**LOW VOLTAGE CIRCUIT BREAKER
SALES & SERVICES**

NO. YAMA344

Indication Change of cULus label for NF50-SMU

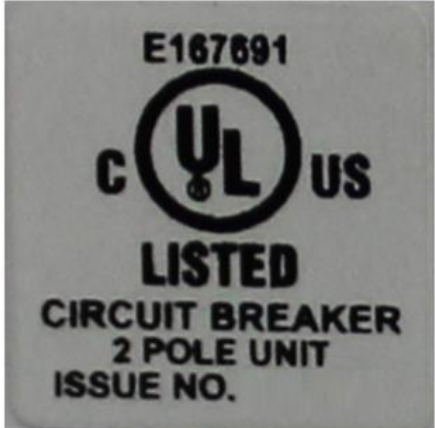
Part of change	Before change	After change
<p>Example: NF50-SMU 2P</p>  <p>cULus label</p>	 <p>Heat transfer printing</p>	 <p>UV(Ultra Violet) printing</p>

※Only printing method is changed, and there is no effect on the description and performance of product.
